PM4 – Public Meeting in Dallas, Pennsylvania

1 ATLANTIC SUNRISE PROJECT
2 (DOCKET NO. CP15-138-000)
3
4 PUBLIC COMMENT MEETING ON THE
5 DRAFT ENVIRONMENTAL IMPACT STATEMENT
6 JUNE 16, 2016
7 7:00 p.m.
8
9
10 Lake Lehmon High School
11 1128 Old Road 115
12 Dallas, PA 18612
13
14
15
16 Court Reporter A
17
18
19
20
21
22
23
24
25

Figure 1: Pennsylvania Watersheds & Unconventional Wells Drilled (2004 - June 30, 2015).

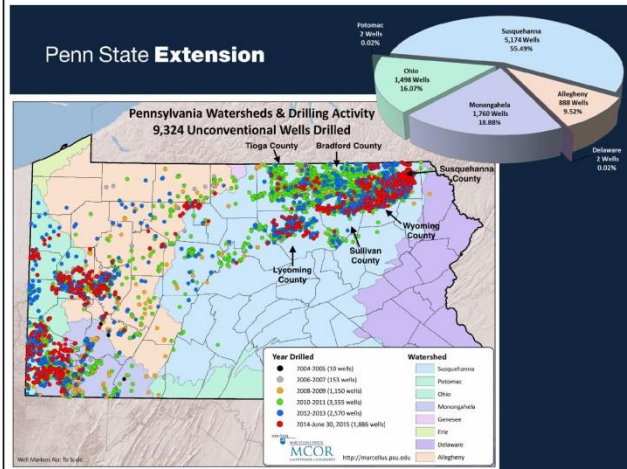
FERC cannot claim to have considered the cumulative impacts of shale gas development on the Upper, Lower, and West Branch Susquehanna Watersheds when it only considered the wells permitted “within 10 miles” of the Atlantic Sunrise Project. As Figure 1 shows, at least 5,174 shale gas wells were drilled in the Susquehanna River Basin between 2004 and June 30, 2015, substantially more than the number of wells considered in the DEIS.

FERC appears to have further limited its analysis of shale gas impacts on watersheds to consumptive water uses only. Although FERC acknowledges that “[c]oncerns have been raised regarding the potential impact of Marcellus Shale development on surface water resources,” DEIS at 4-274, nowhere does FERC discuss impacts such as increased erosion and sedimentation and pollution from wastewater spills that are caused by shale gas development. This is a major oversight in a basin that has approximately 55% of all shale gas wells in Pennsylvania. *See* Figure 1.

Figure 2: Total Confirmed Bobcat Observations, 2006-2011.

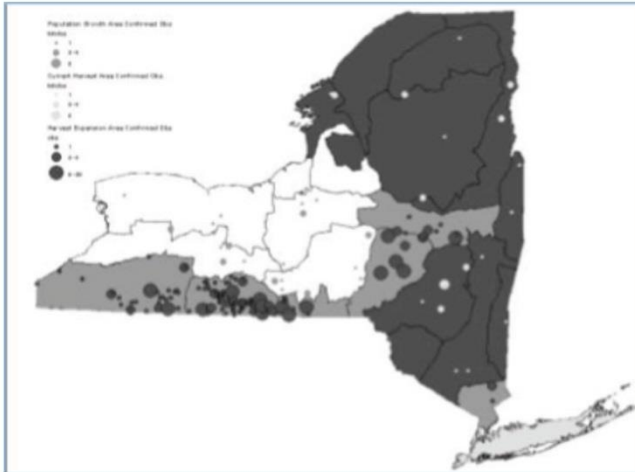
While NYDEC was documenting an increase in bobcat observations in the southern tier of New York between 2006-2011, hundreds and then thousands of shale gas wells were being drilled in the northern tier of Pennsylvania. See Figure 2 above. As Figure 2 indicates, between 2006-2011, gas companies drilled at least 4,858 shale gas wells in Pennsylvania. Many of these wells were drilled in Pennsylvania's northern tier. Thus, at the same time the gas industry began and then rapidly escalated gas drilling across the northern tier of Pennsylvania, the bobcat population in the southern tier of New York "increased dramatically." Since there has been no shale gas

Figure 3: Proposed “Greenfield” Pipeline Projects Impacting the Appalachian Basin.

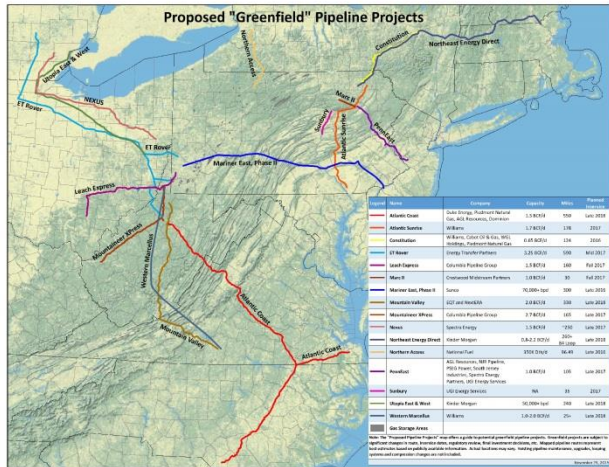
As Figure 3 shows, there are at least nine greenfield pipeline projects totaling over 2,500 miles targeting shale gas supplies in the OH-PA-WV tri-state area. This would expand gas capacity out of this region by 13.45 Bcf/d and NGL capacity by 120,000 bpd. In other words, “several proposed actions are pending at the same time . . . that will have cumulative or synergistic environmental impacts upon a region.” *Kleppe*, 427 U.S. at 409-410. FERC cannot stick its head in the sand and ignore the cumulative impacts of these projects while it incrementally authorizes this massive infrastructure build-out.

This is precisely what FERC should be doing for gas-related infrastructure that aims to connect Appalachian Basin shale gas to market areas. As Figure 3 shows, there are "several proposals . . . that will have cumulative or synergistic environmental impacts upon [the Appalachian] region [and they] are pending concurrently before [FERC]." *Kleppe*, 427 U.S. at 410. Therefore, "their environmental impacts must be considered together" in a comprehensive PEIS. *Id.* By preparing a PEIS, FERC could employ a more "thoughtful and broad-based
